ADDENDUM NUMBER TWO

SOLID WASTE SCALE AND FEE BOOTH RELOCATION

DATE OF ADDENDUM: April 12, 2024

Number	ASI 01
Date Issued	04.05.24
MOR Studio Project Number	2214
Project	Prescott Solid Waste Fee Booth
ASI Created By	Lisa Blanchard

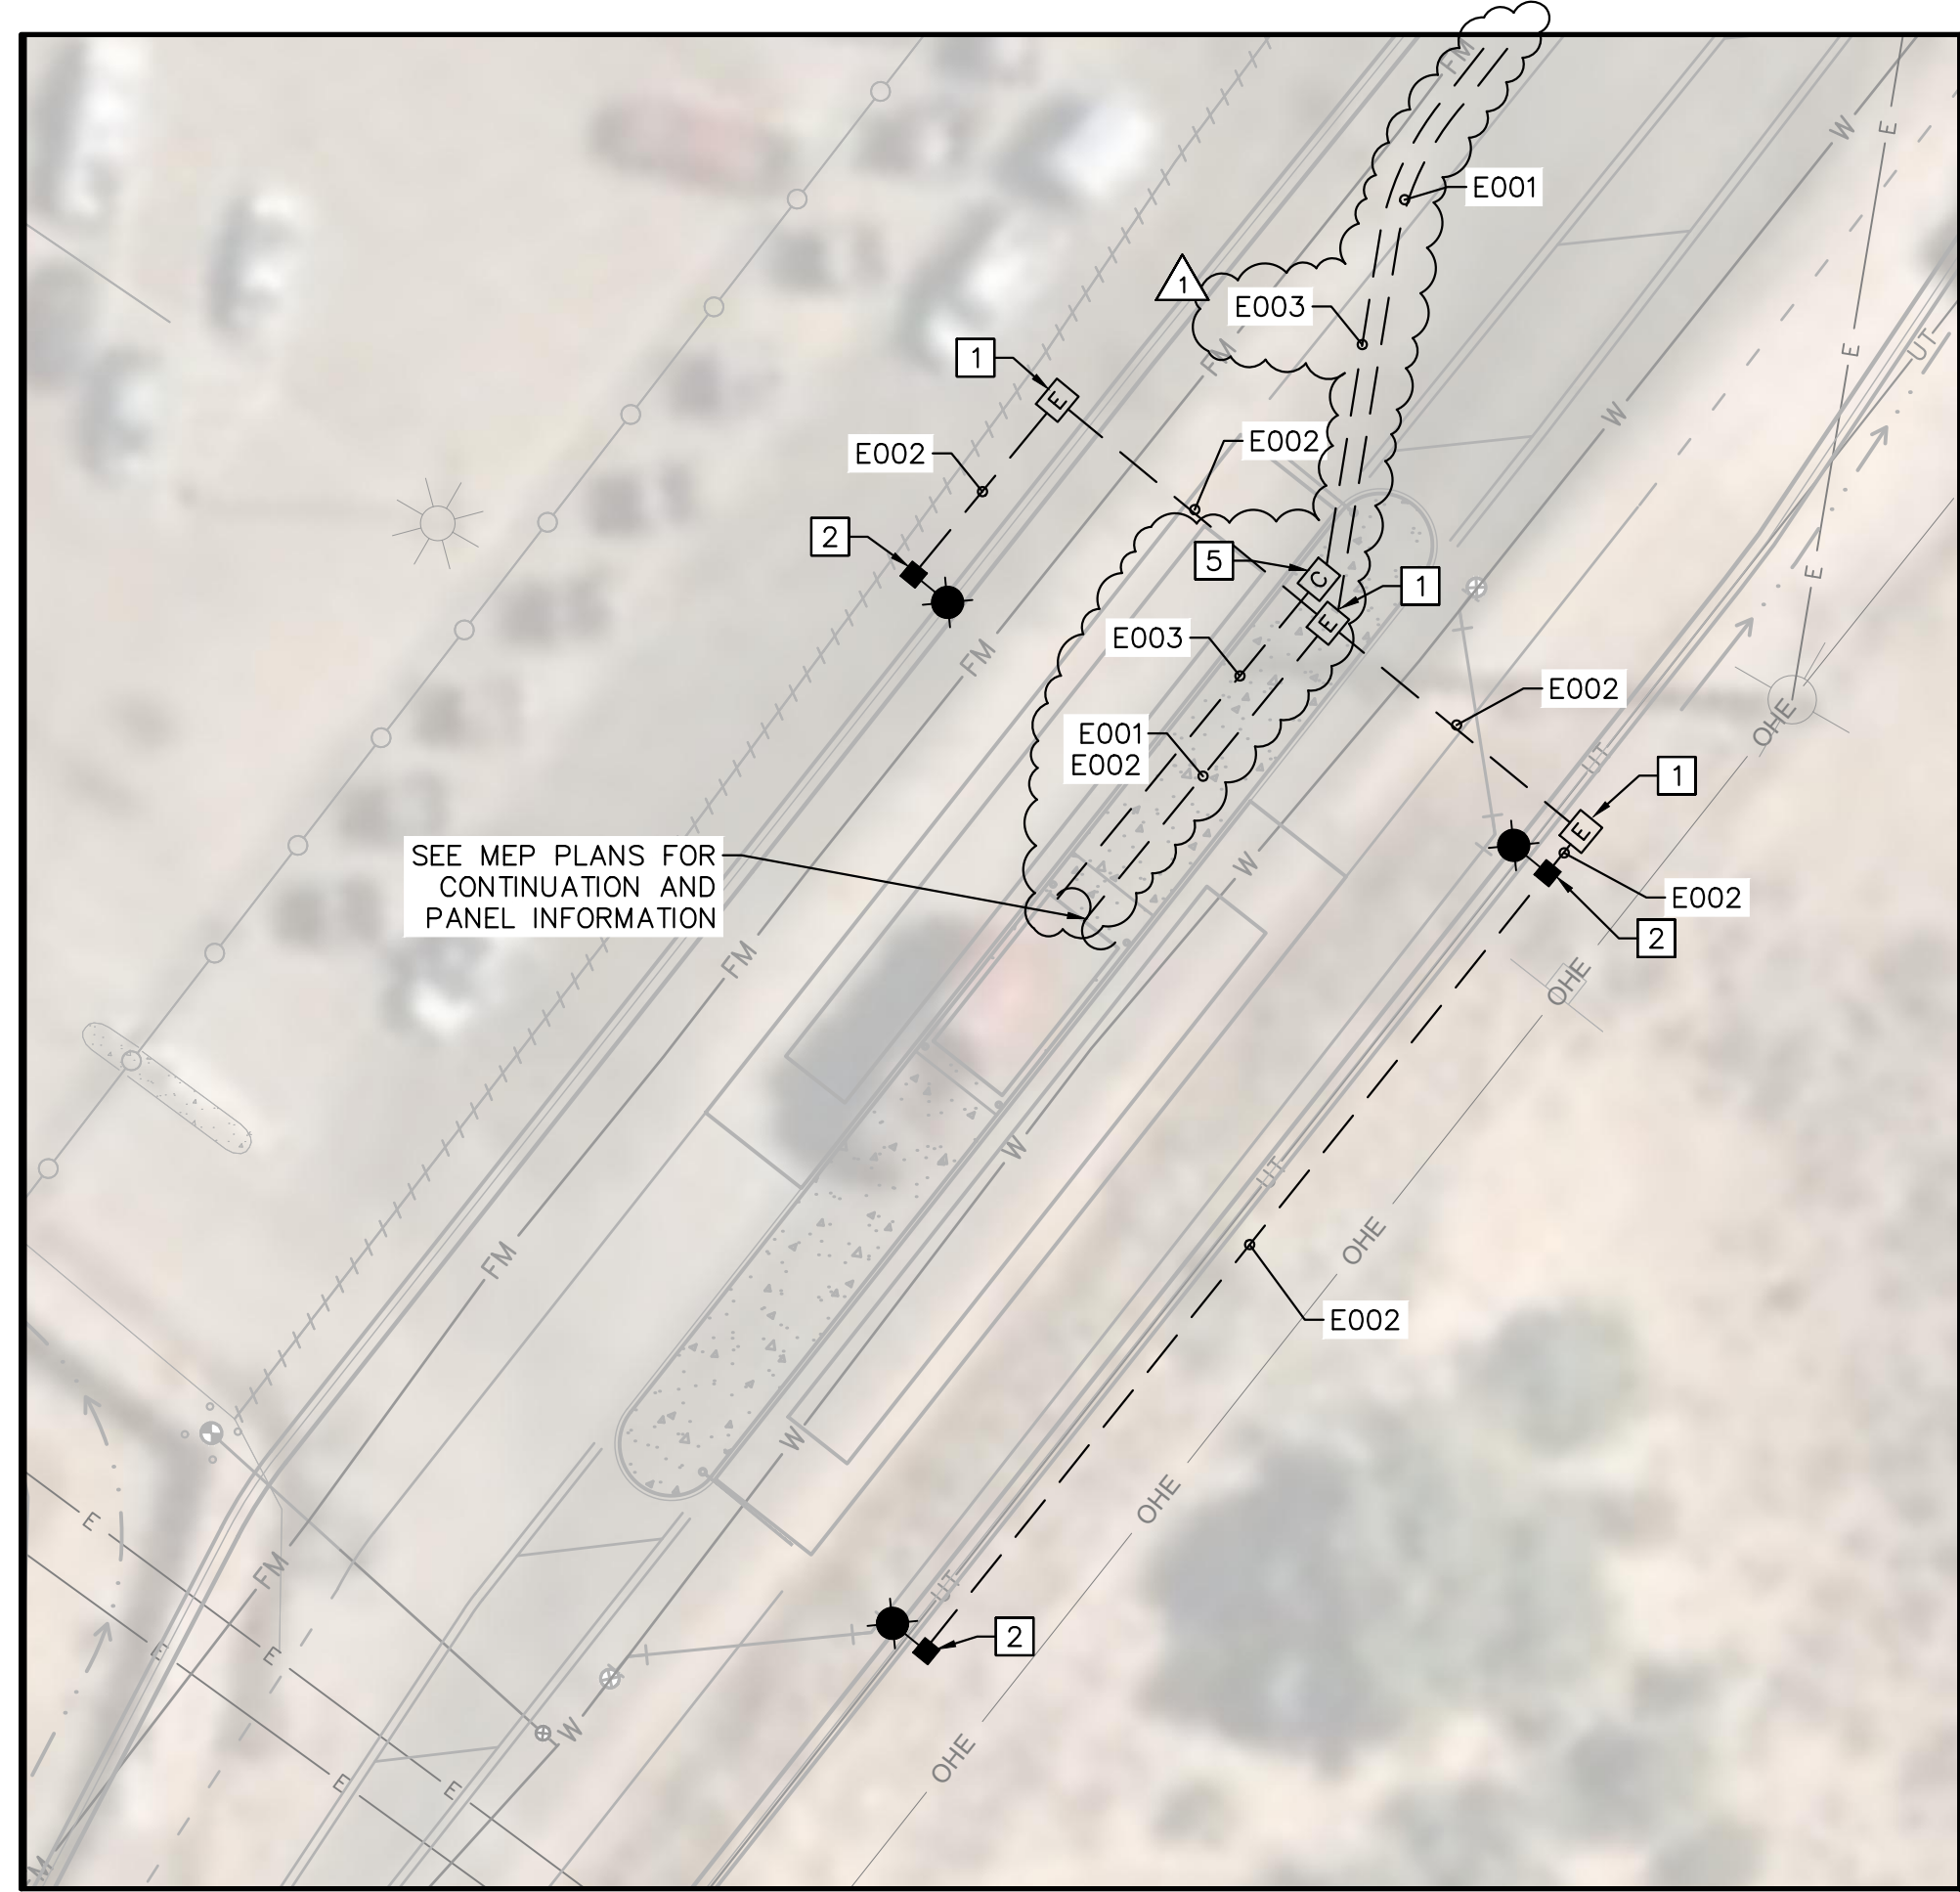
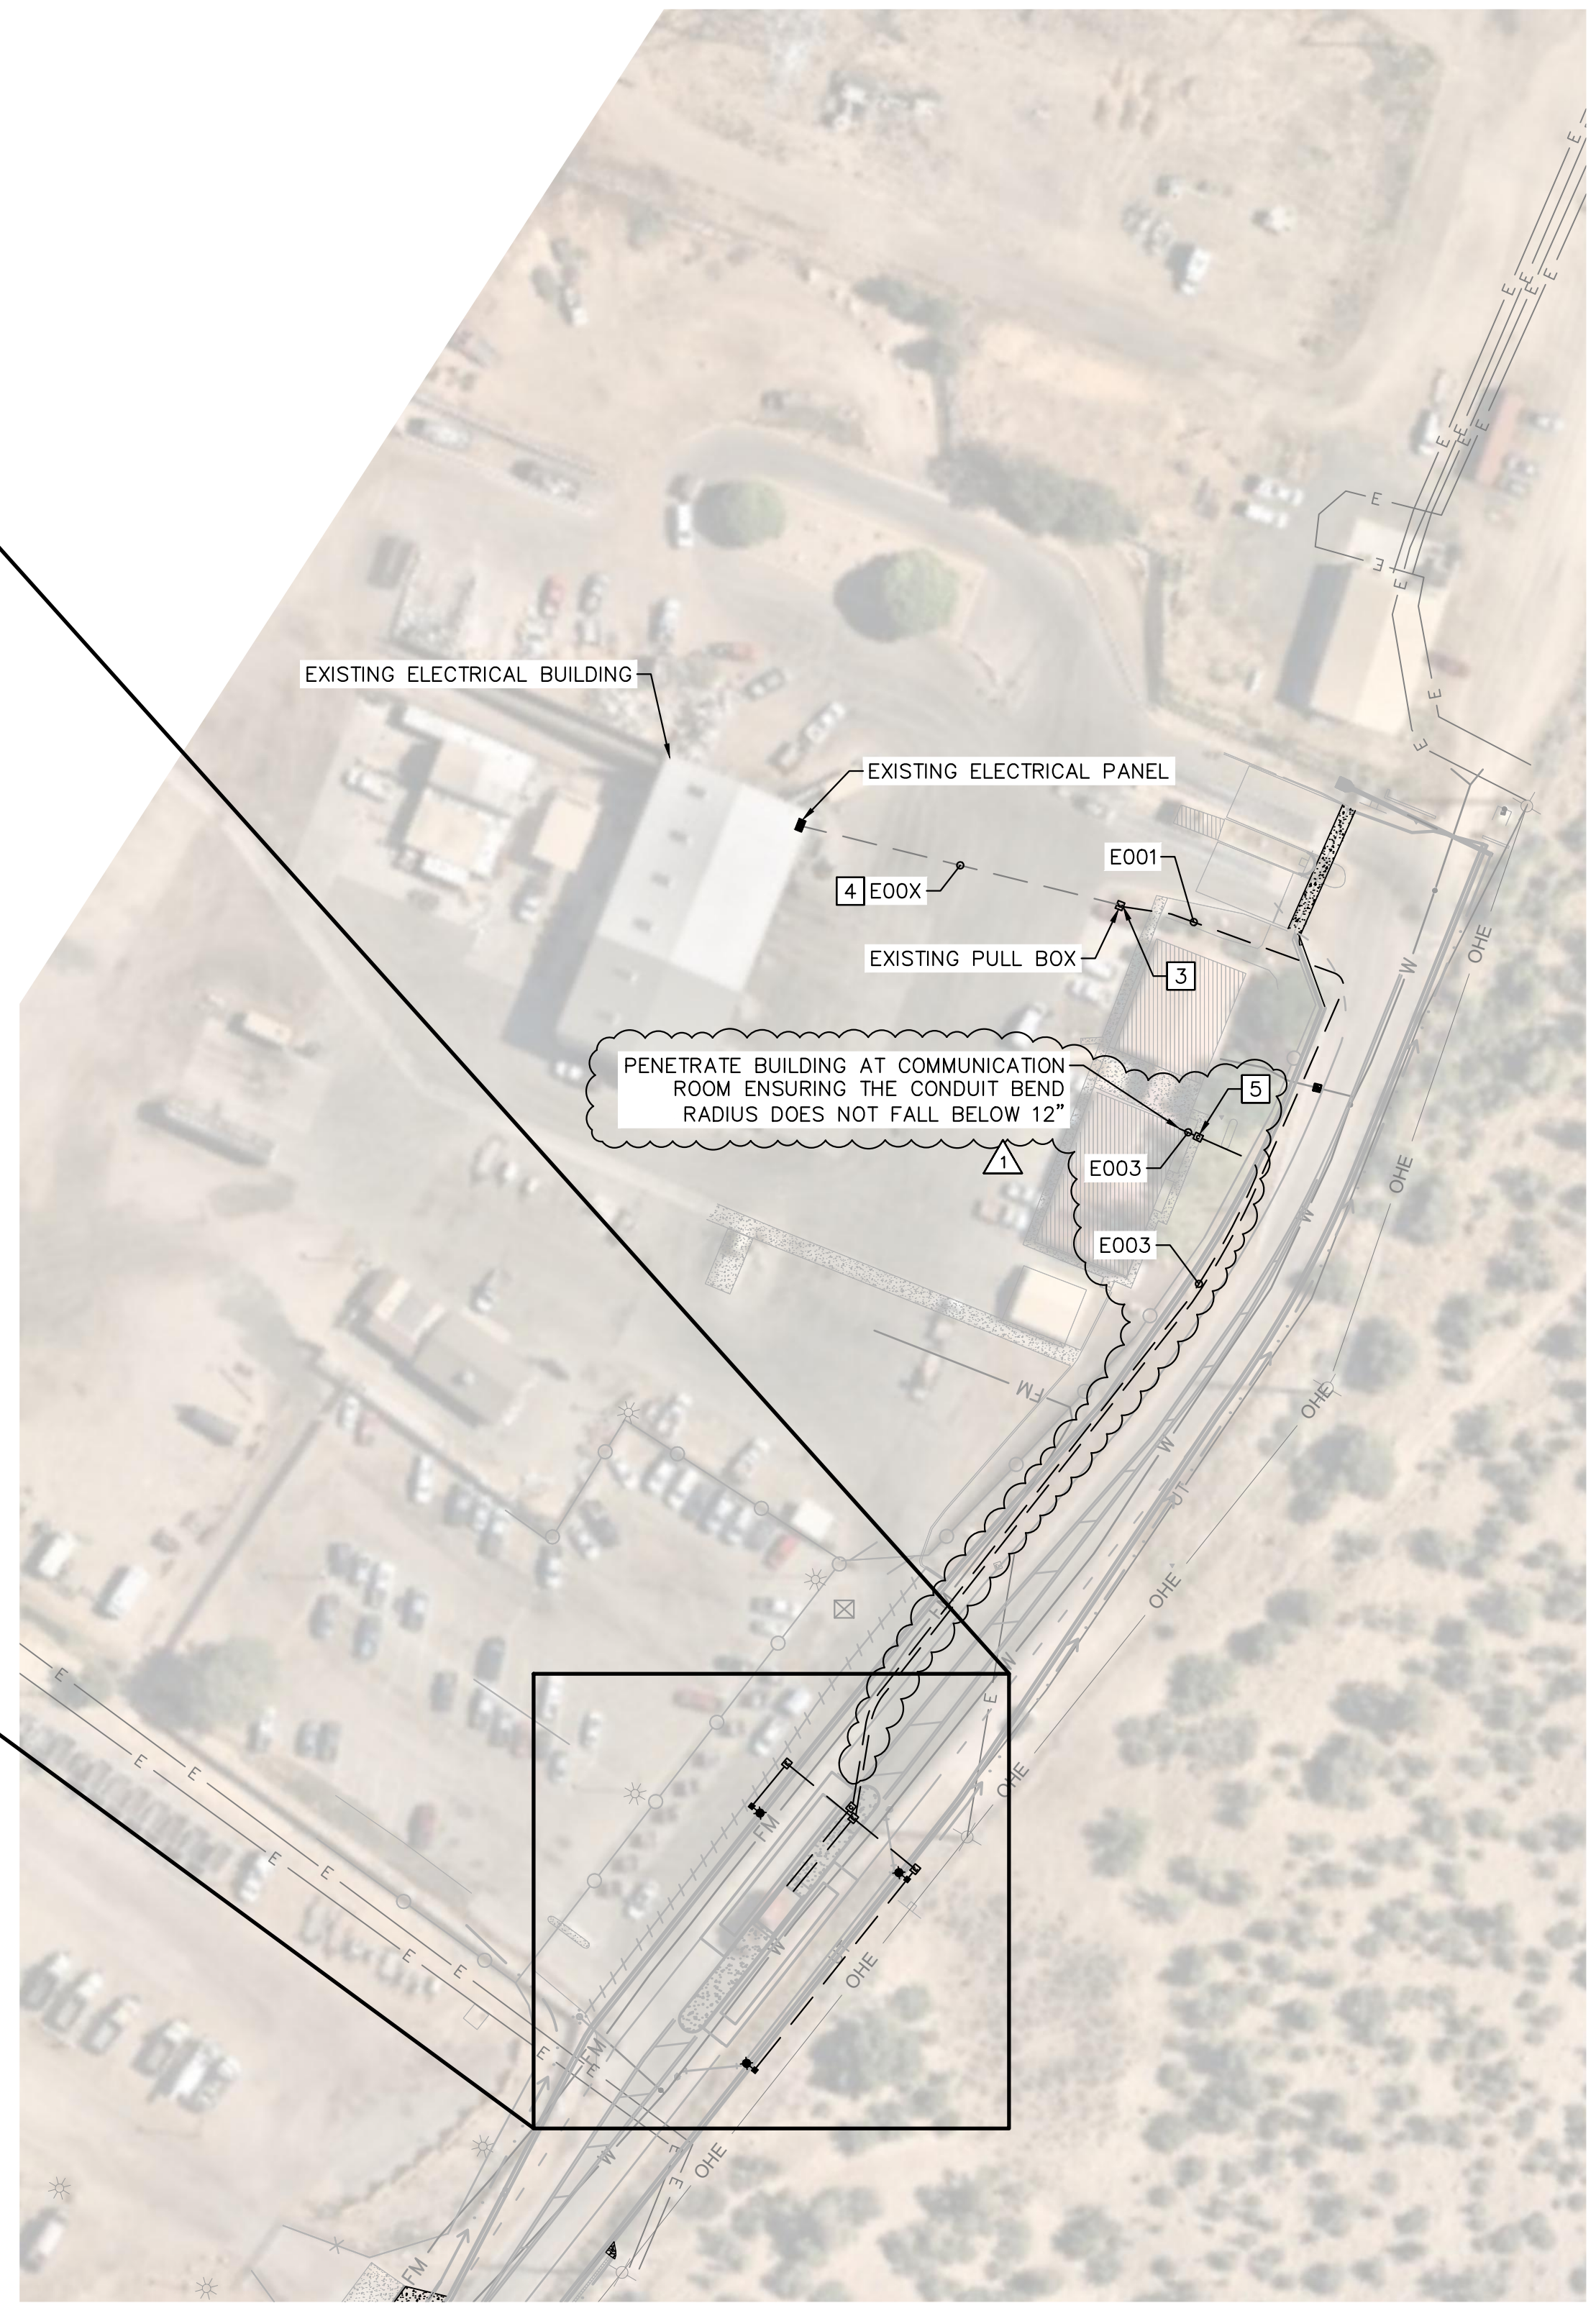
Emailed Question: Need location and quantity of the pole lights. Need a site plan.

Sheet 25 – Added conduit and pull boxes for communications lines from administration building to the fee booth.

Response: The pole lights are shown on sheet 25 of the plan set. Plans and Bid Form call for 3 pole lights.

C CONDUIT AND CONDUCTOR SCHEDULE
SCALE: N.T.S.

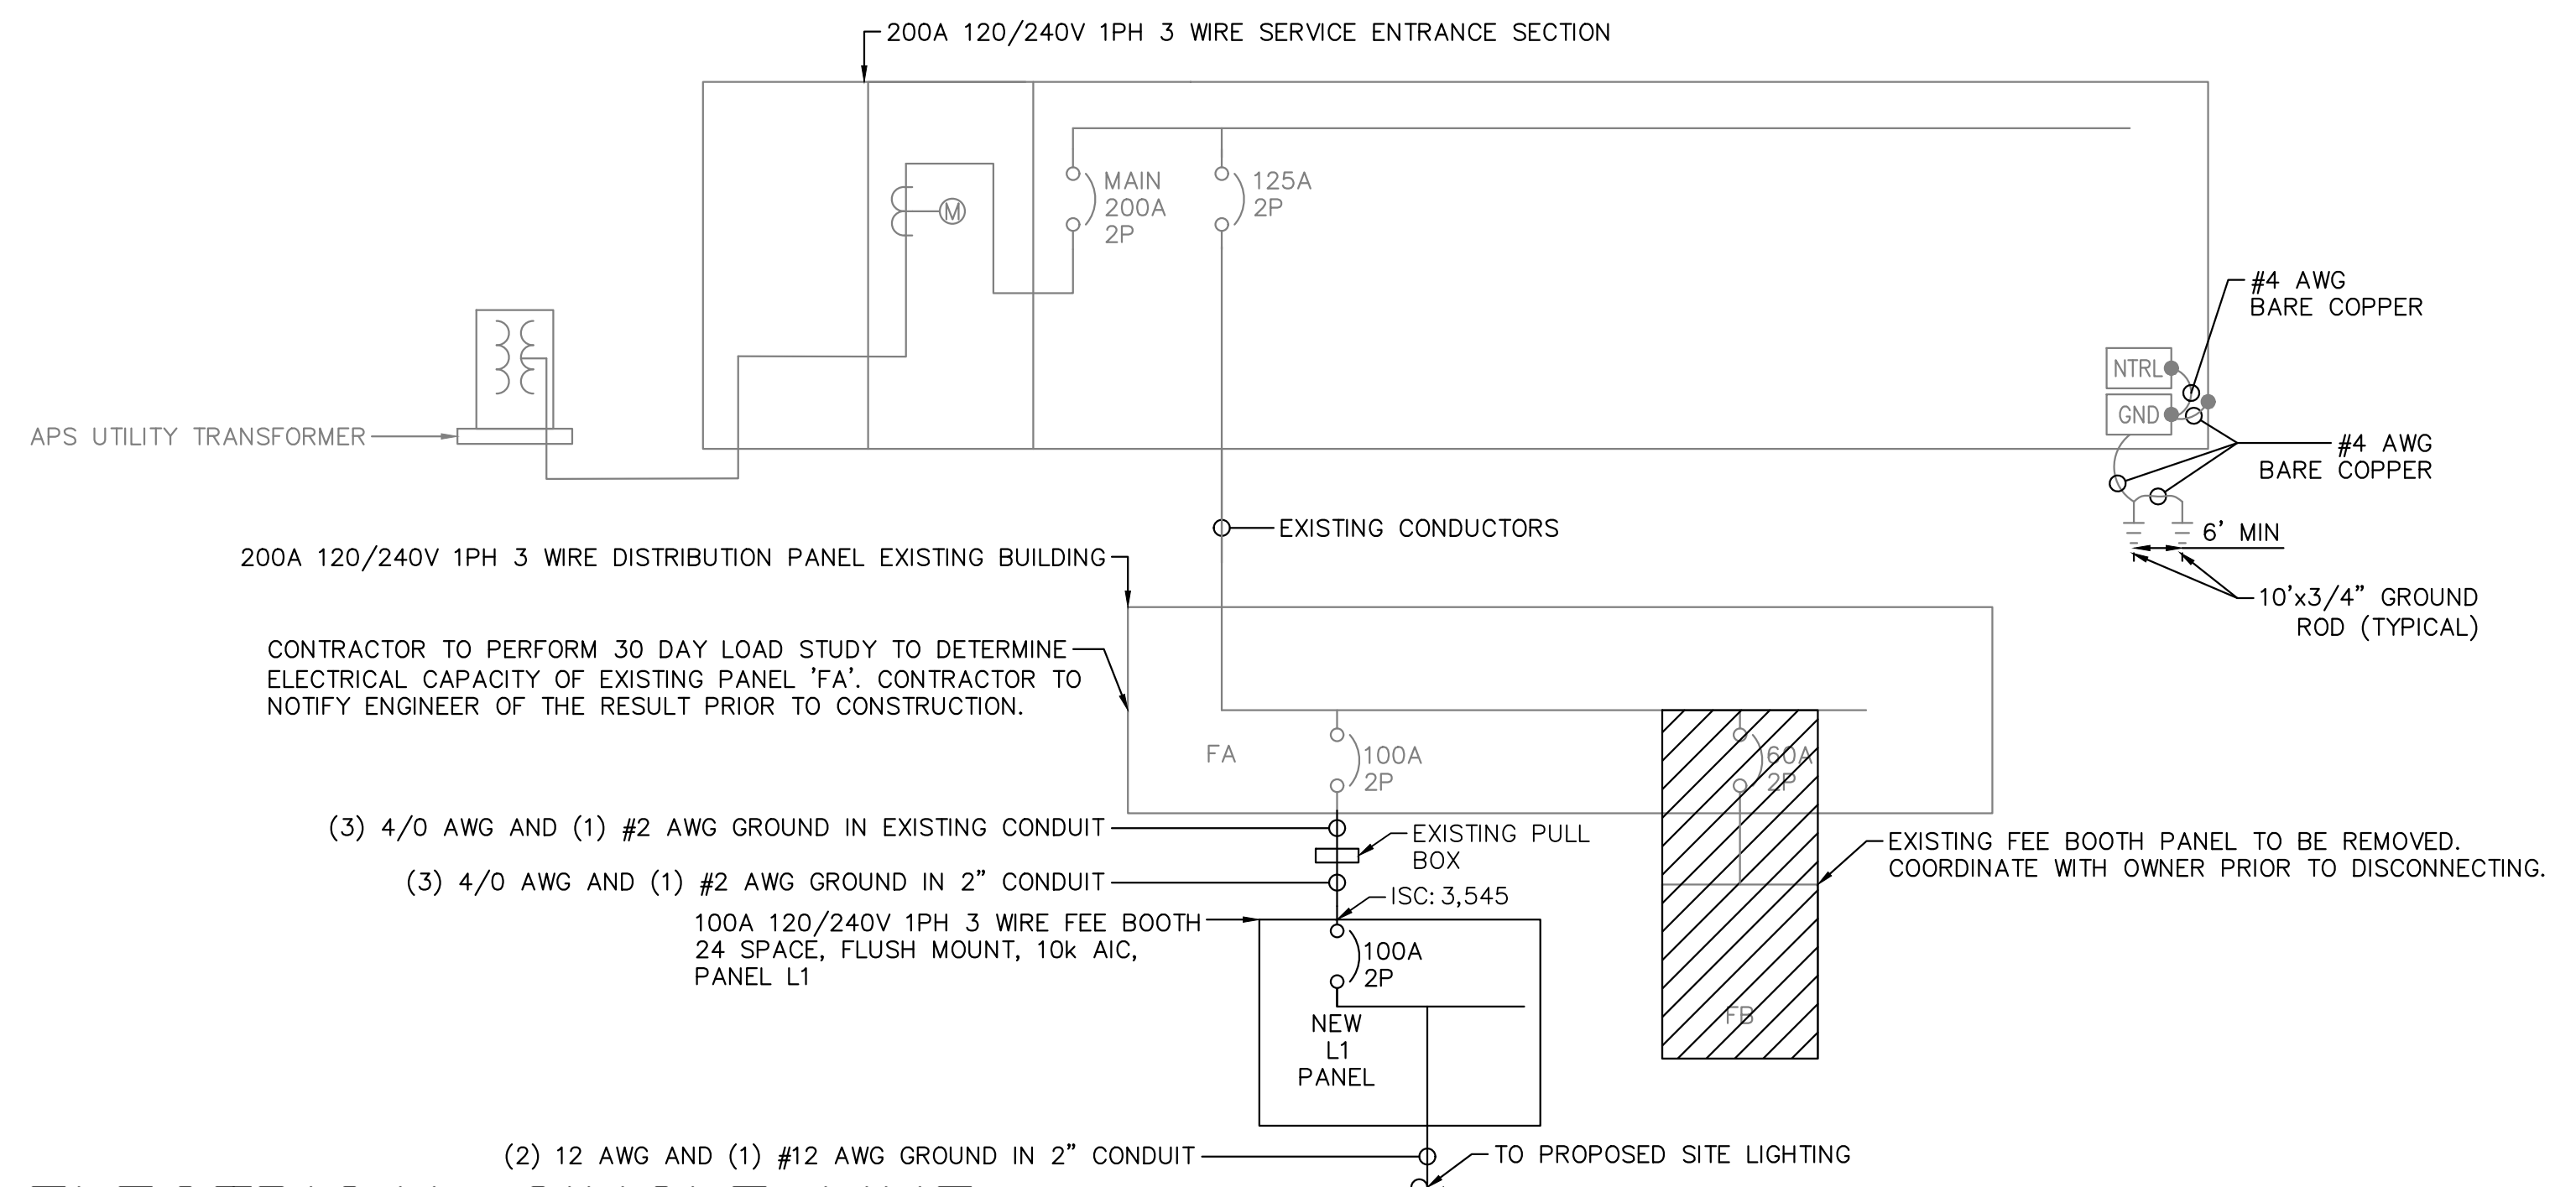
Sheet 28 – Updated conduit and conductor table.
